Re: April 27 and April 30, 2009 Clean Water Act Inspection

NPDES COMPLIANCE EVALUATION INSPECTION

NPDES Permittee: MYD Samoa, Inc.

Facility: Satala Shipyard
P.O. Box 7684, Pago Pago, Tutuila Island, American Samoa
(NPDES Permit No. AS0020026)

Photo #7: Catch Basin #1 – April 2008
Taken By: Greg V. Arthur
Date: 04/01/08

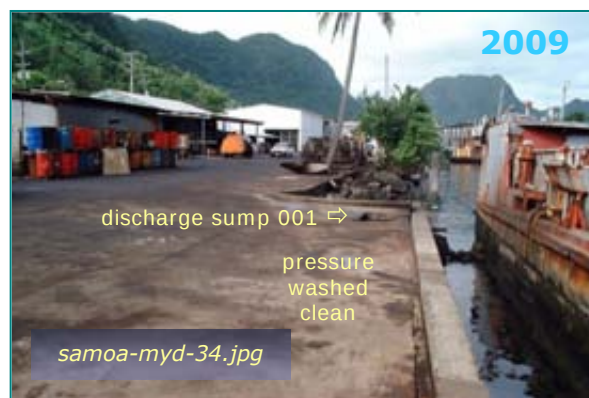
Catch Basin #1 Drainage – Catch Basin #1 includes the piers and landings around the 800-ton dry dock and two buildings. Catch Basin #1 was observed to be swept, in order, cleaned, and pressure washed, with no significant pollutant sources left exposed to contact with storm water run-off. The numerous pollutant sources observed last year were no longer found. In particular, the open storage of spent blasting grit and material debris adjacent to the 800-ton dry dock and the winch room was entirely removed. The trash piles, oily barrels, spent materials, and equipment on the landing were also removed. The pavement between the dry dock and harbor was pressure washed clean. There was curbing along the open harbor but not around the 800-ton dry dock. Catch Basin #1 drainage collects to a sump outfitted with siphon overflows to the harbor, designated as discharge point NPDES-001. No oily drainage was observed flowing into and through the discharge sump and no sheen was observed in the harbor around NPDES-001. See Photos #3, #4, #7, #8, #9, and #10 in Section 1.6 on page 10.
